**RE: Young Ranch Resource Quarry, M-2021-009
TR-01 Adequacy Response 1**

This is the response to your adequacy questions dated December 4, 2023. Each question is addressed in line and updated documents are attached as needed.

C-2A Phase 1 SWMP Map
Young Ranch Resource

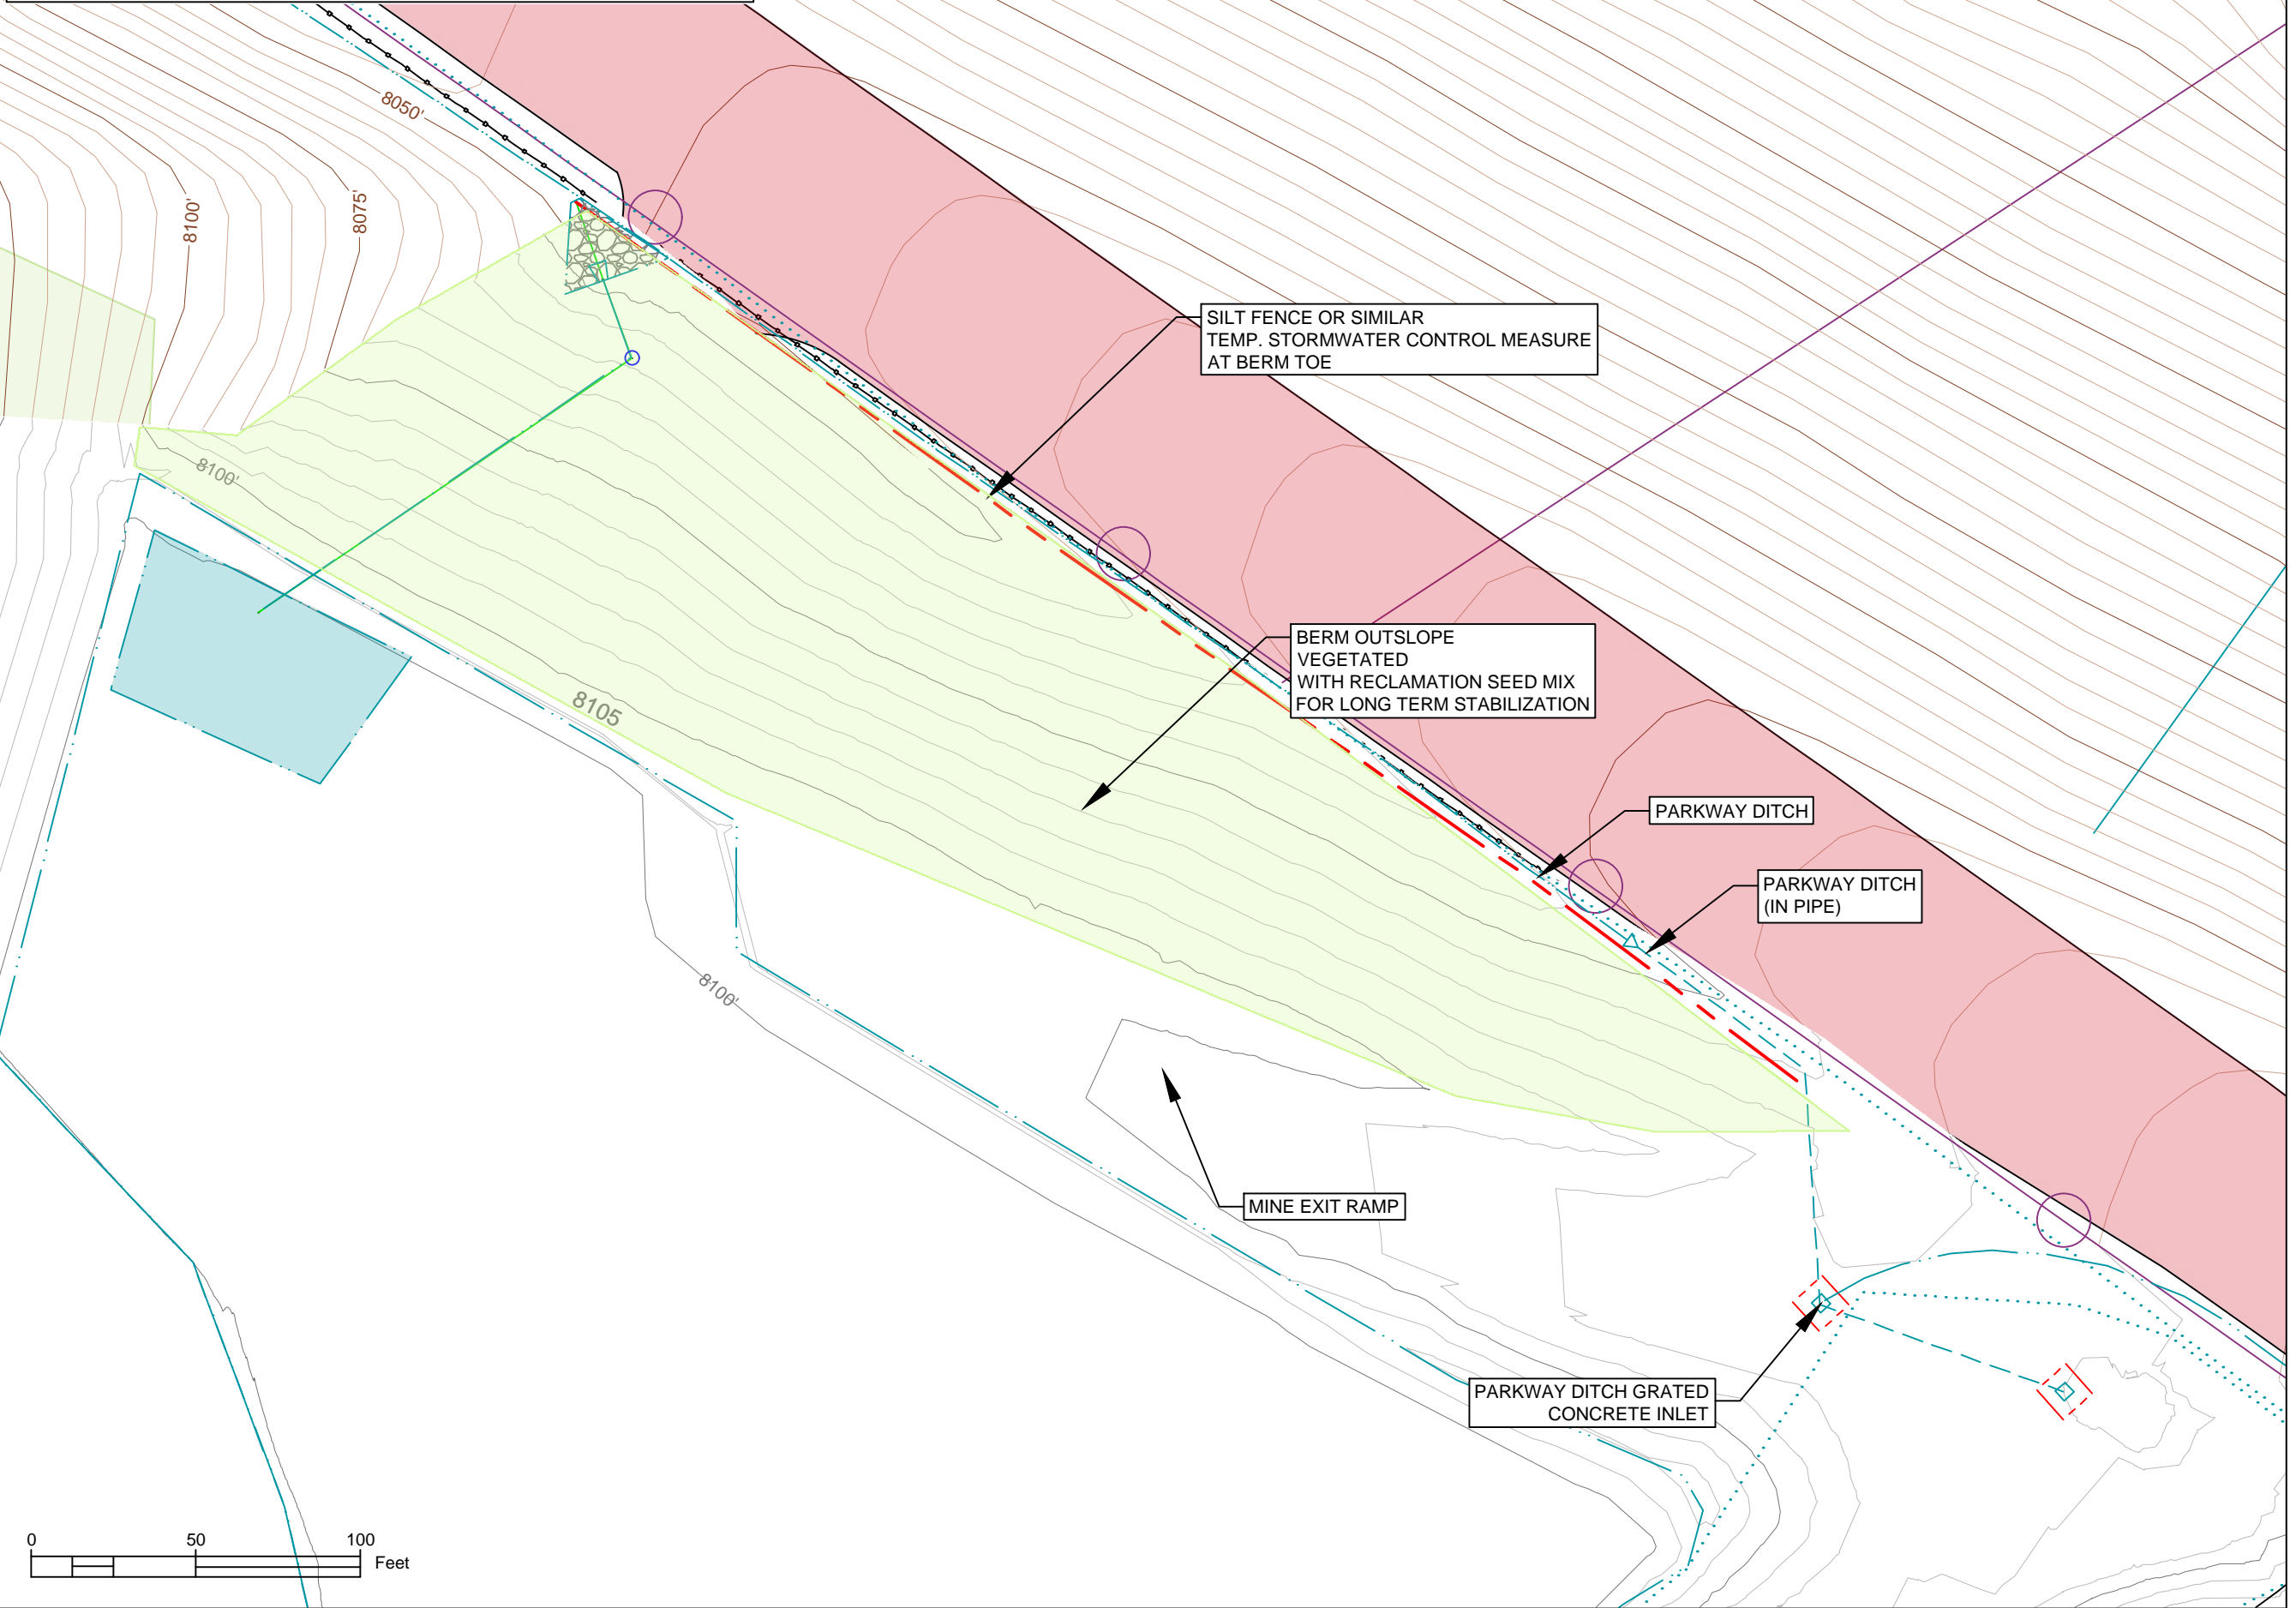
- 1. The scales on some of the submitted maps appear to be incorrect and need to be checked and revised as necessary. For example, the scale on Map C-2A indicates that the Central City Parkway (CCP) is approximately 200 feet wide. That is highly inaccurate.*

All map scales have been checked, corrected as needed, and updated maps are attached.

C-6 END OF PHASE 4
YOUNG RANCH RESOURCE

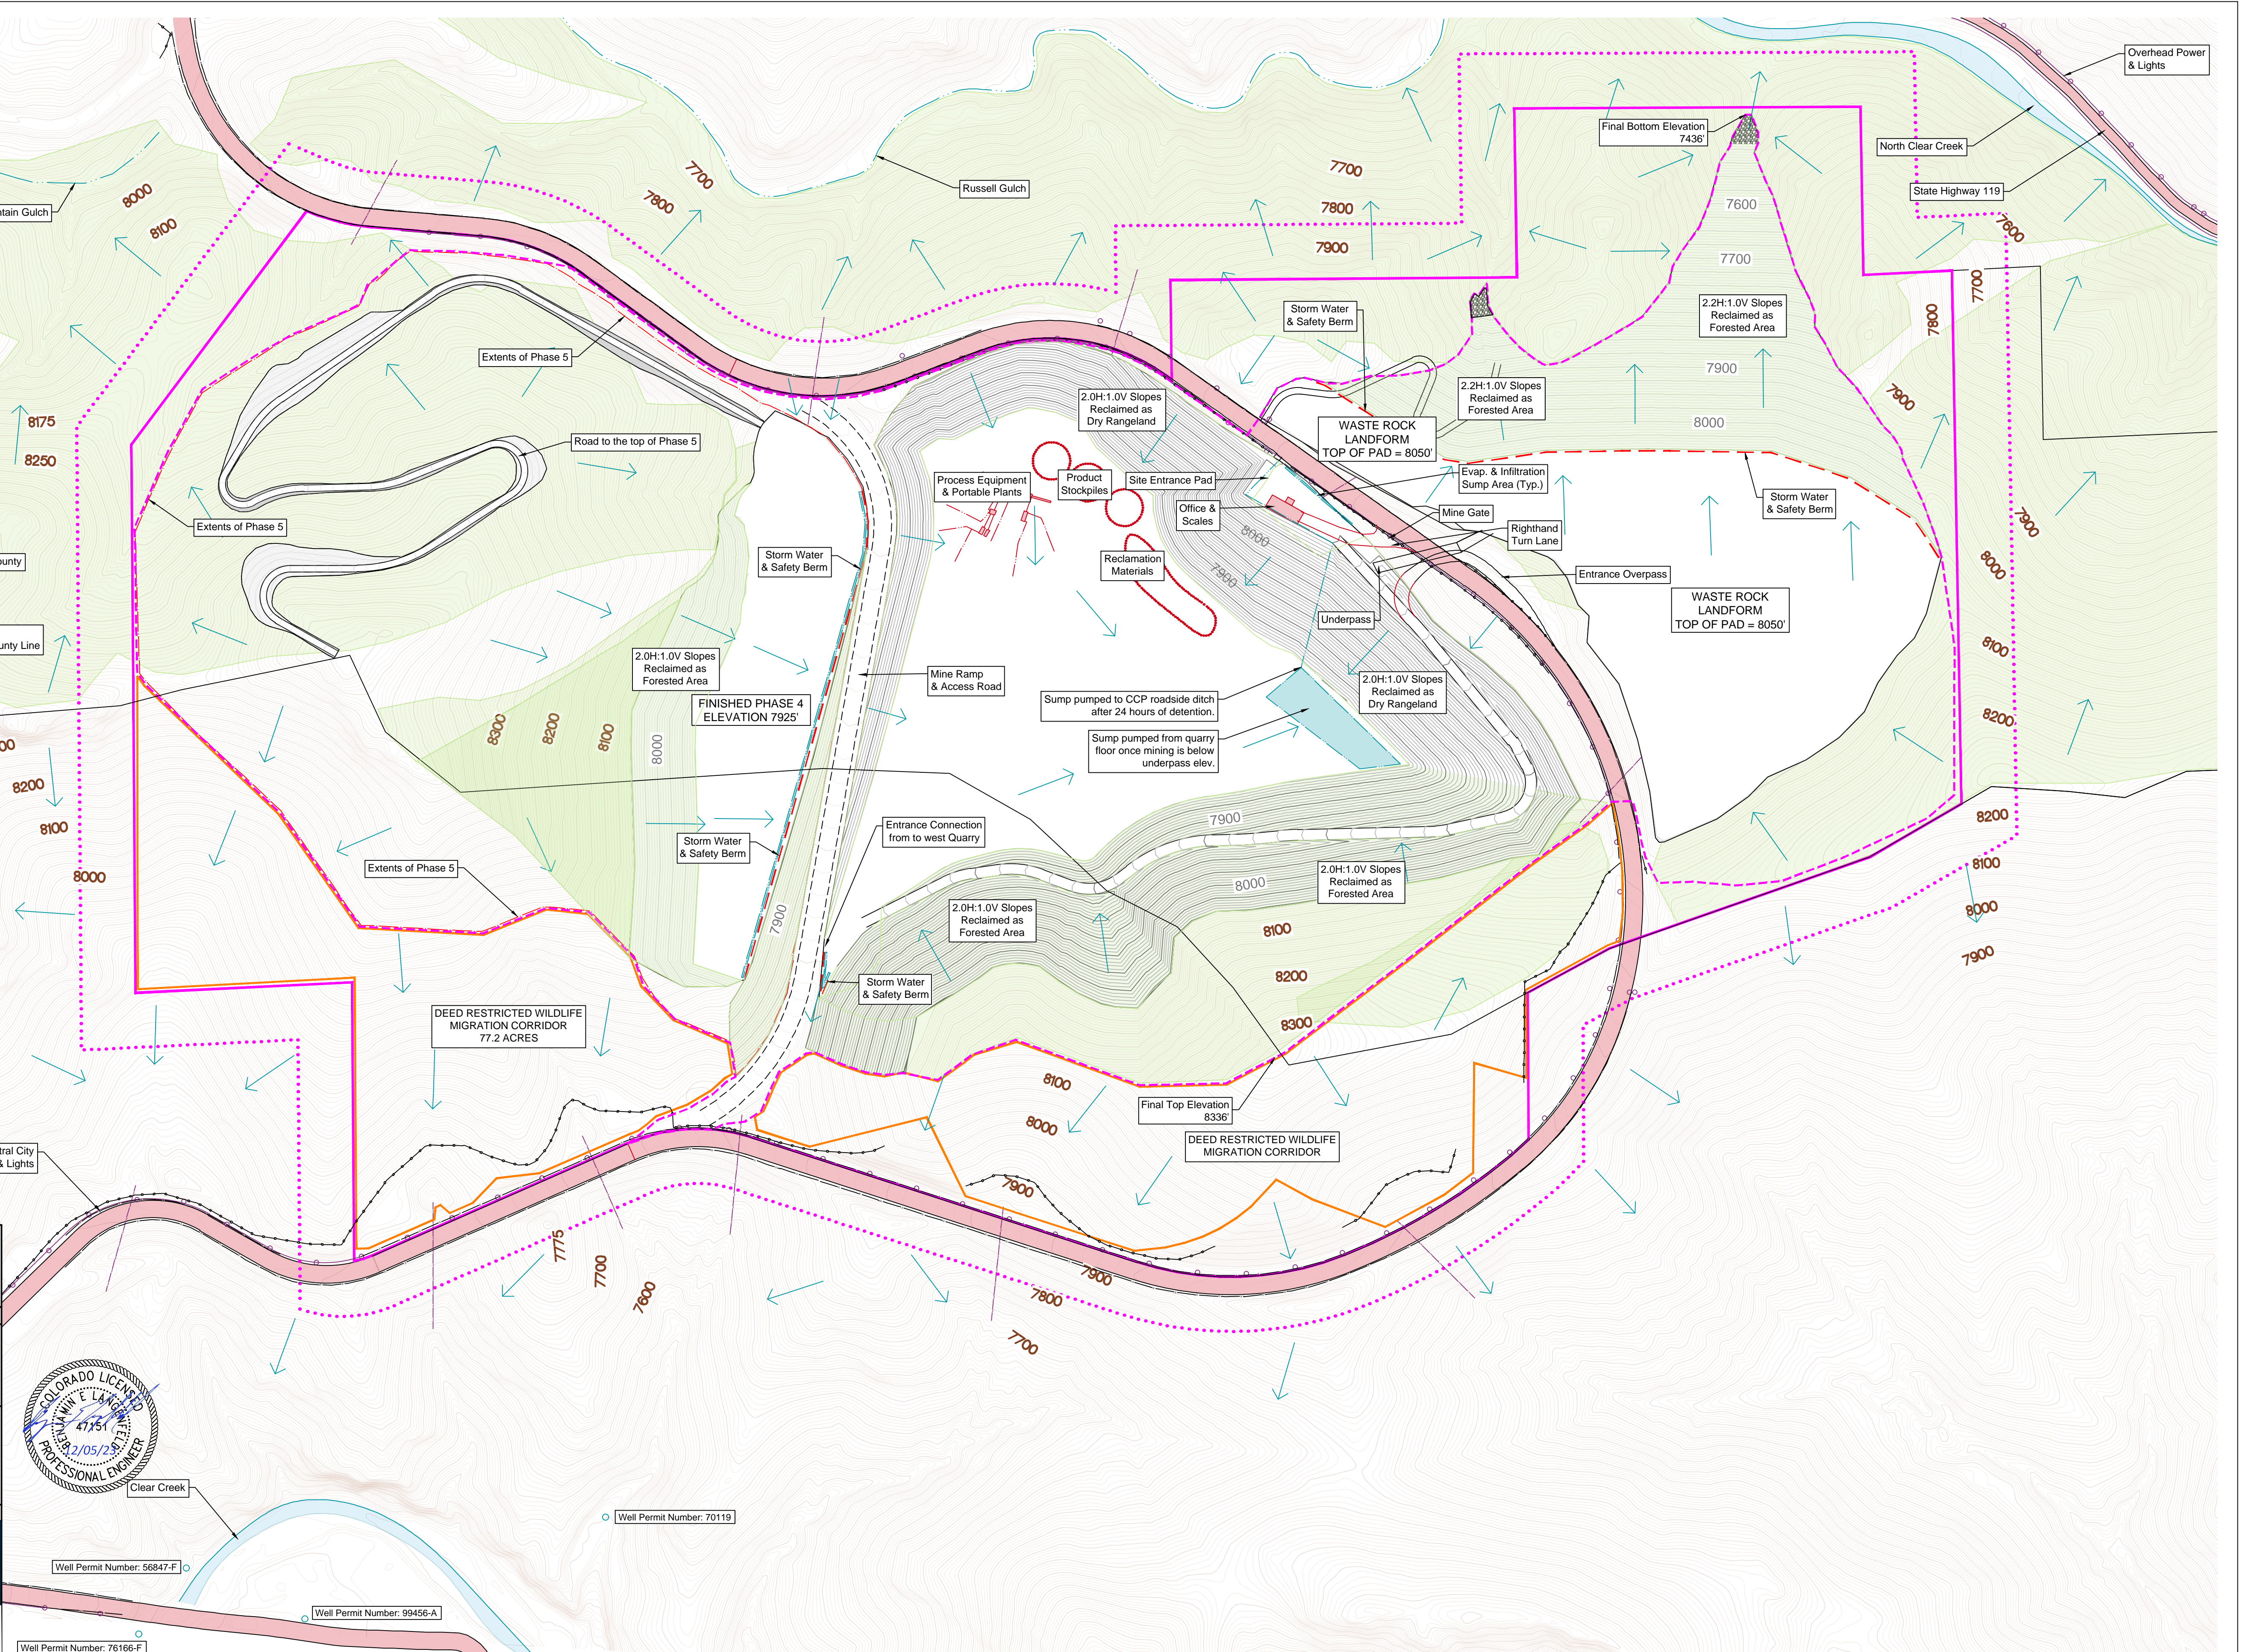
5. *The entrance to the mine from the east has been changed from an underpass into an overpass. Maps C-4 thru C-7 need to be updated to show this change.*

Maps C-4 through C-7 have been revised to show the changes to the site access.
